This gallery shows some pictures of bad solderings - they should prevent you from making the same errors (feel free to add even more pictures here!)

2008/12/01 09:18 home:skills:bad_solderings_gallery http://wiki.midibox.org/doku.php?id=home:skills:bad_solderings_gallery&rev=1228123119

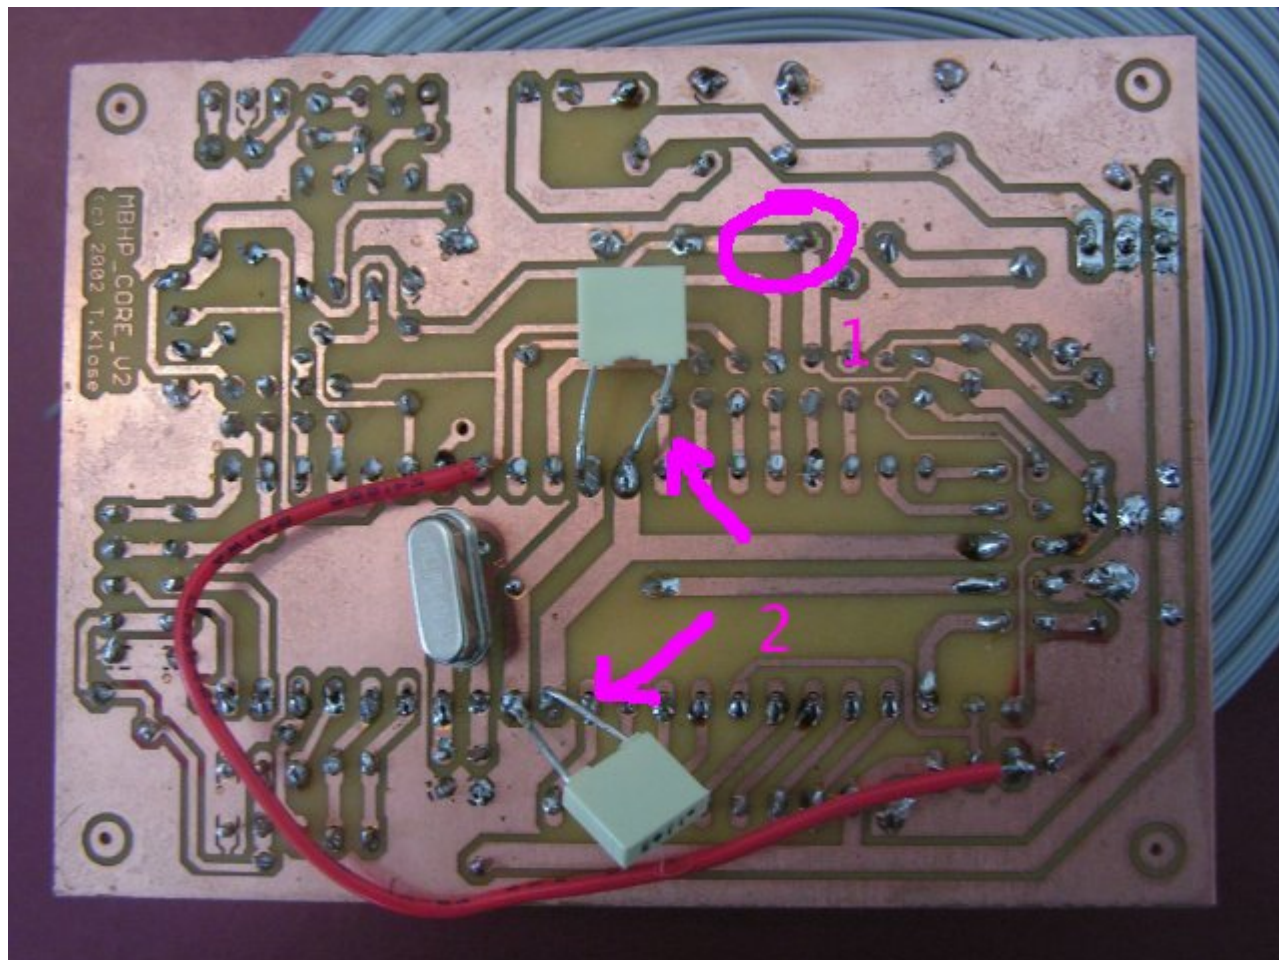
1: The core module has some badly soldered connections(loose), which could lead to failures. There are also missing solderings (e.g. 33pF cap below crystal). It makes sense to solder each pad again, the [Soldering](#) guide in the Wiki gives some useful tips

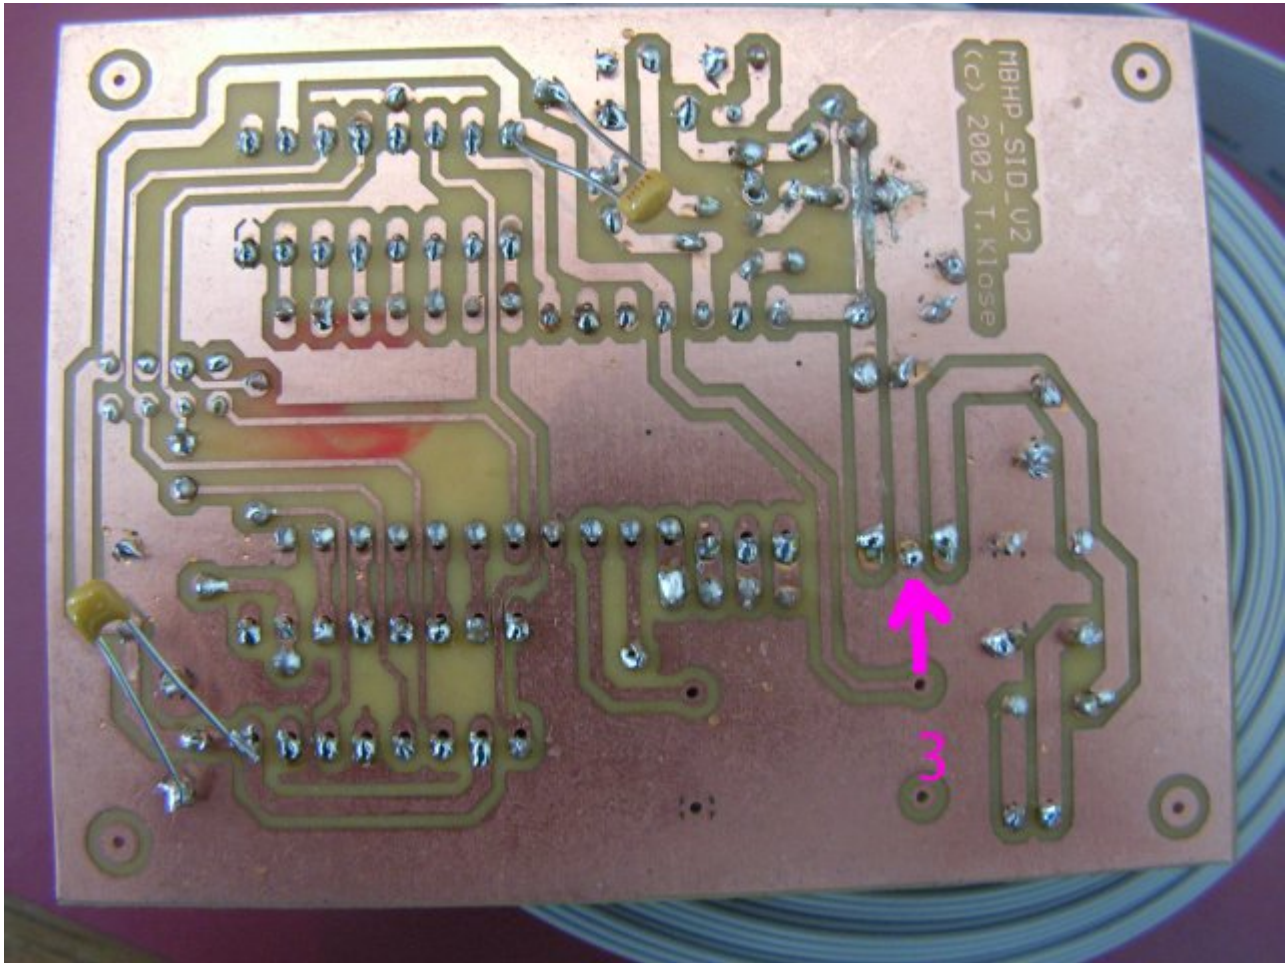
2: The legs of the caps should be cut, otherwise they can cause a short circuit which can damage the PIC!

3: This seems to be a bad ground connection directly at the 78xx - it can lead to the wrong voltage. Here the same: just solder the pads again, it will help
And same as above: the long cap legs need to be cut, the danger of shorting out is too high!
